Property Information	100 Breckenridge Trace – Premier Transportation		
Address	100 Breckenridge Trace, Kingsport, TN		
Tax Map, Group, Parcel	Tax Map 106, Parcel 026.51		
Civil District	14 th Civil District		
Overlay District	Gateway District		
Land Use Designation	Industrial		
Acres	+/- 2.441 acres		
Existing Use	Vacant	Existing Zoning	MX, Mixed-Use
Proposed Use	Premier Facility	Proposed Zoning	MX, Mixed-Use
Owner/ Applicant Information		Intent	
Name: Thompson & Litton Address: 7 Worth Circle City: Johnson City State: TN Zip Code: 37601 Email: dday@t-l.com Phone Number: (423)-722-1824		Intent: <i>The applicant is seeking Gateway approval, for the construction of a new, MX zoned, Premier Transportation Facility.</i>	
Planning Department Recommendation			
(Approve, Deny, or Defer) The Kingsport Planning Division recommends granting contingent approval for the following reasons: <ul style="list-style-type: none"> Planning staff have reviewed all submissions and recommend giving Gateway approval. The development received Planning Commission approval on May 15, 2025 Premier's sign variance is scheduled for the July 3rd, 2025 Board of Zoning Appeals meeting. Staff Field Notes and Genera

Grading Plan

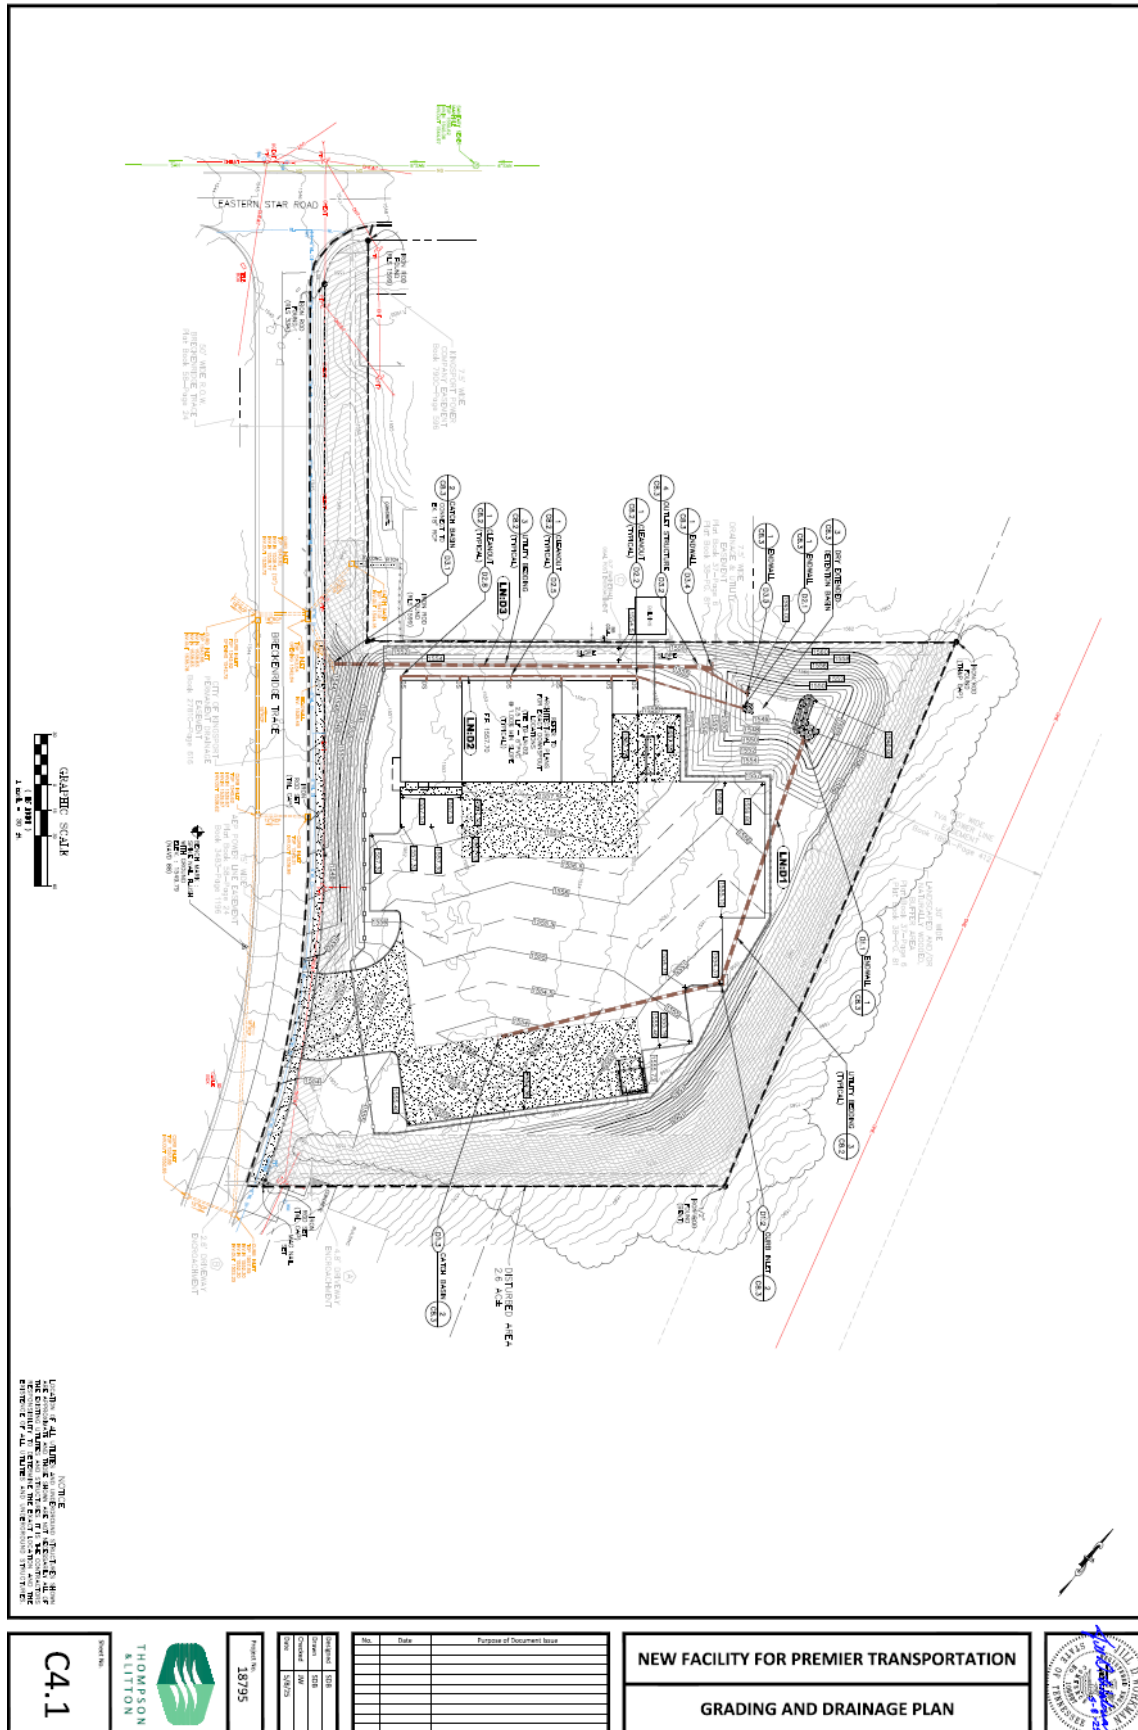
2. Grading Plan

- a. The grading plan shows a minimal amount of land disturbance in line with the Gateway standard.

Architectural Design

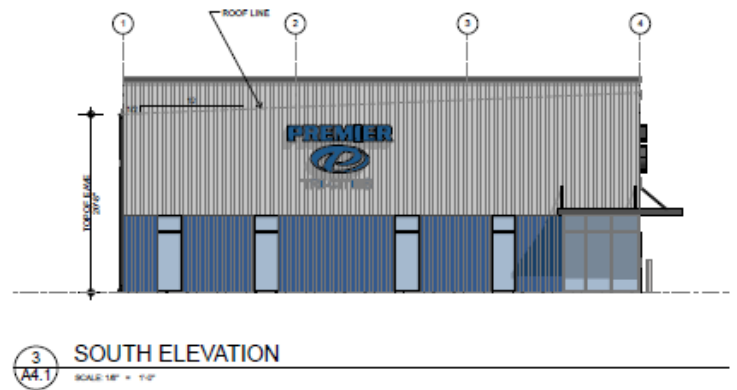
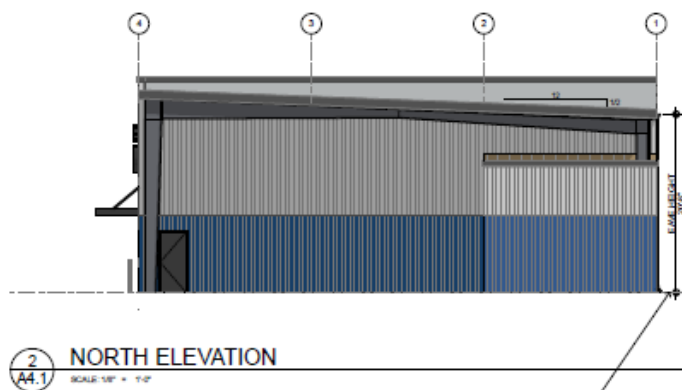
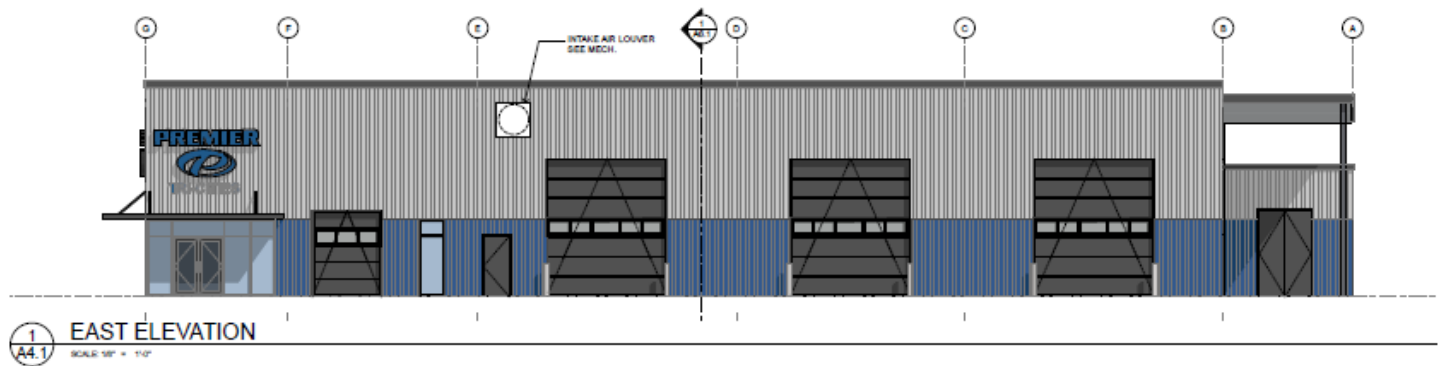
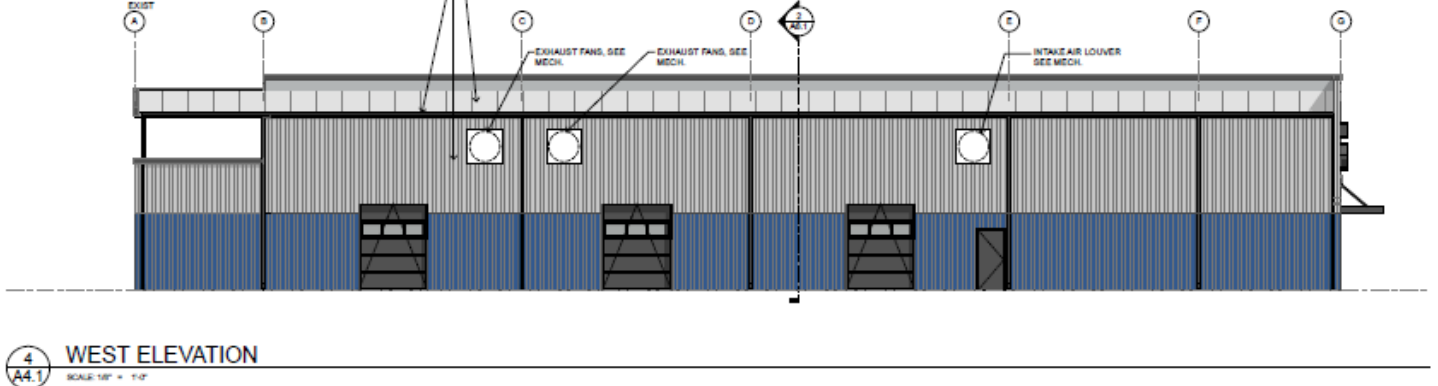
4. Architectural Plans

- a. The architectural plan displays neutral colors and materials such as metal roofing and paneling that matches the design of many of the pre-existing buildings in the area.

Lighting Plan

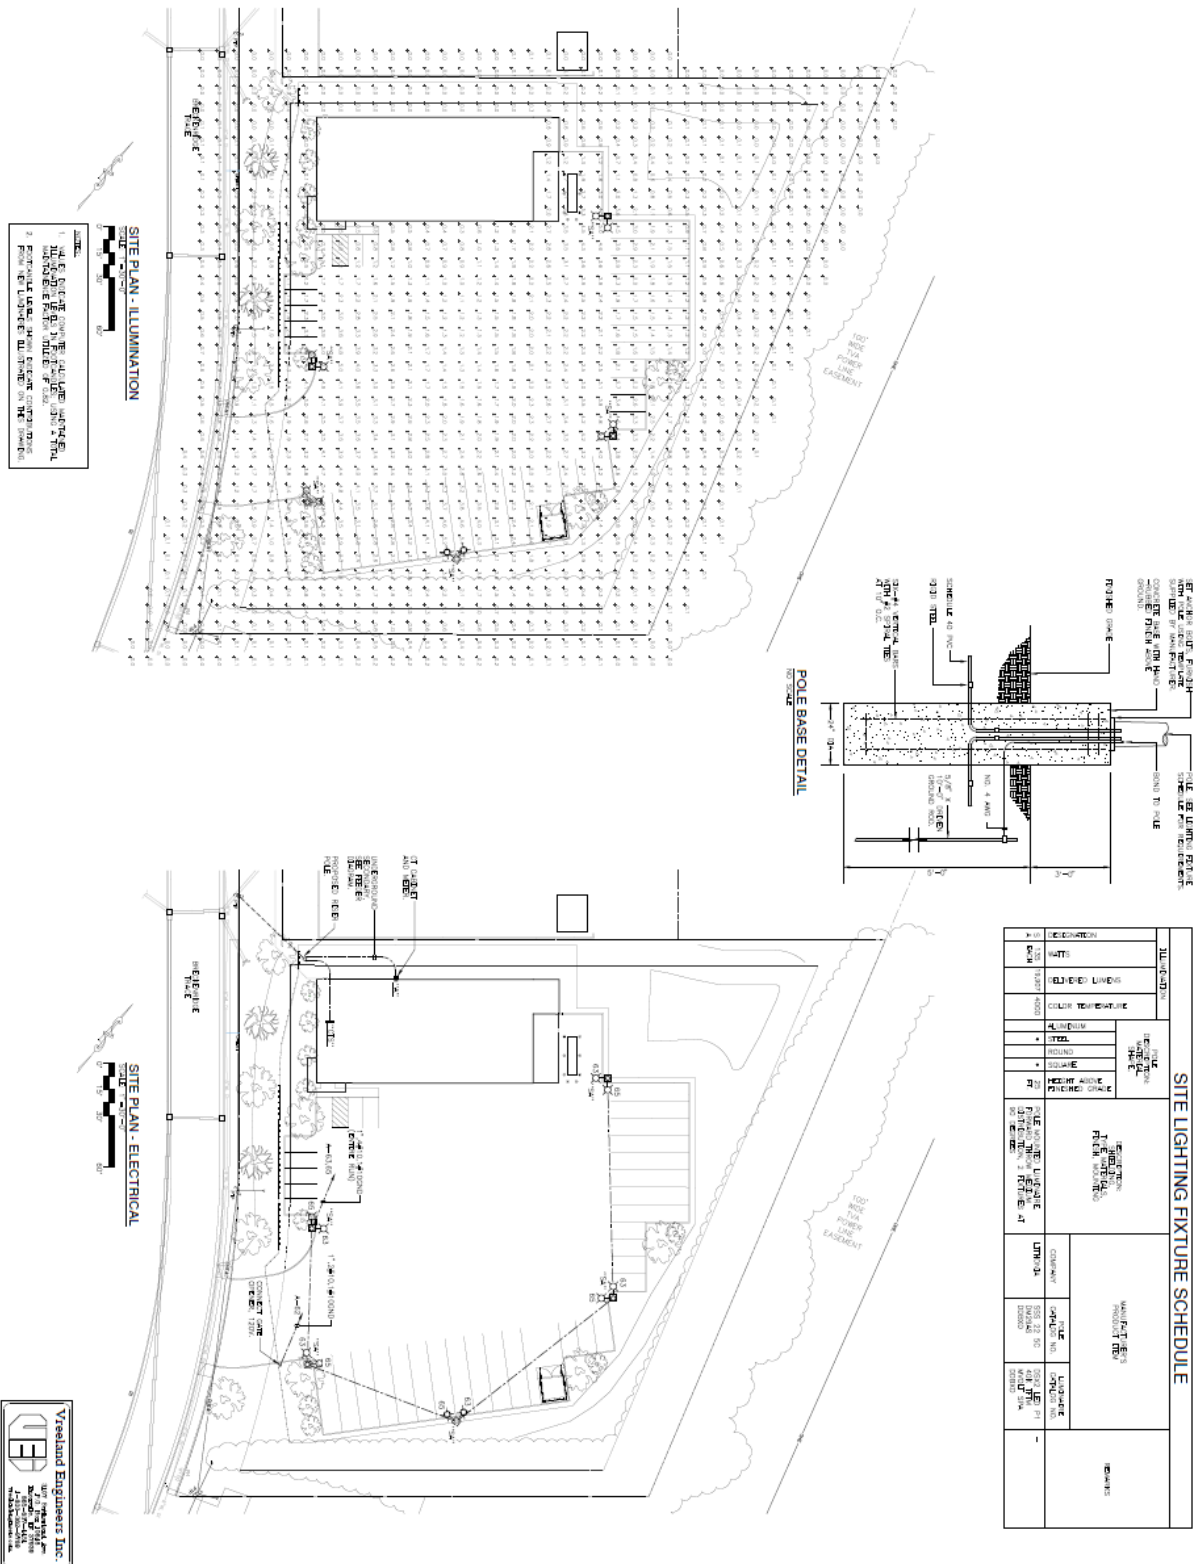
6. Lighting Plan

- a. The lighting plan displays minimal to no disturbance on adjacent properties. Light disturbance will be dampened further by the natural vegetative area located within the 30' development free periphery zone.

Utility Plan

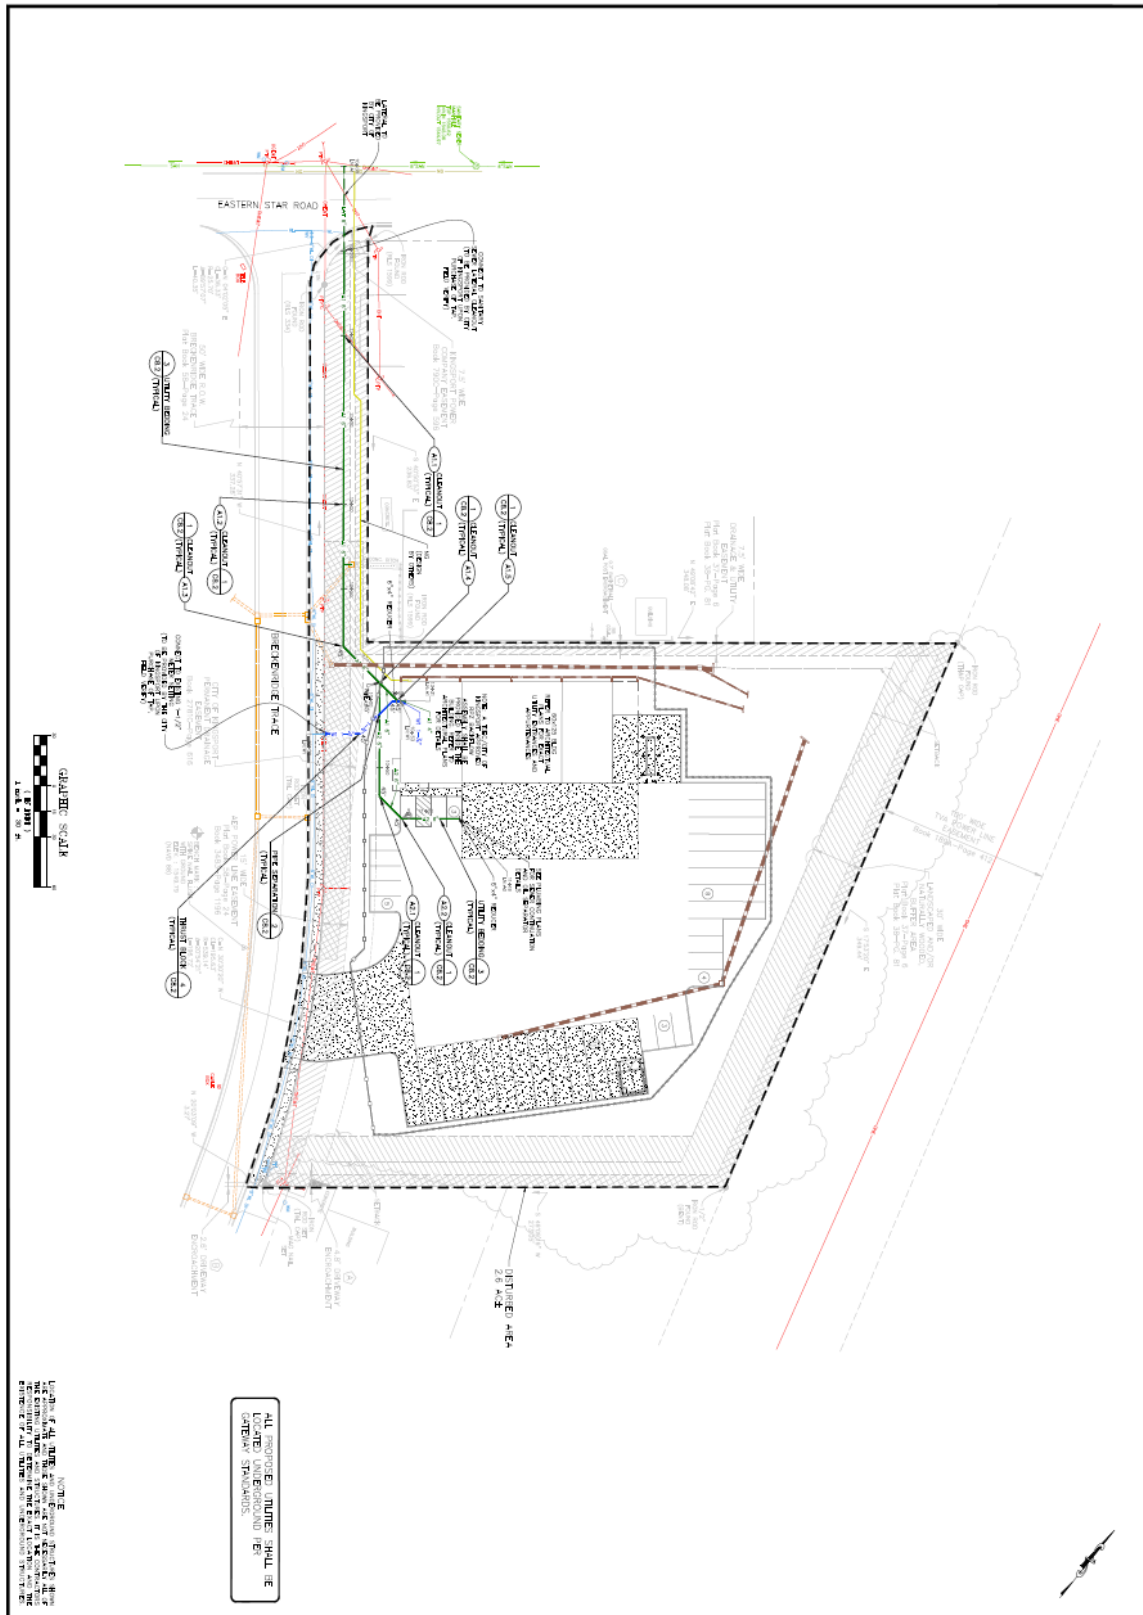
7. Utility Plan

- a. The utility plan notes that all proposed utilities must be located underground per the gateway standard.
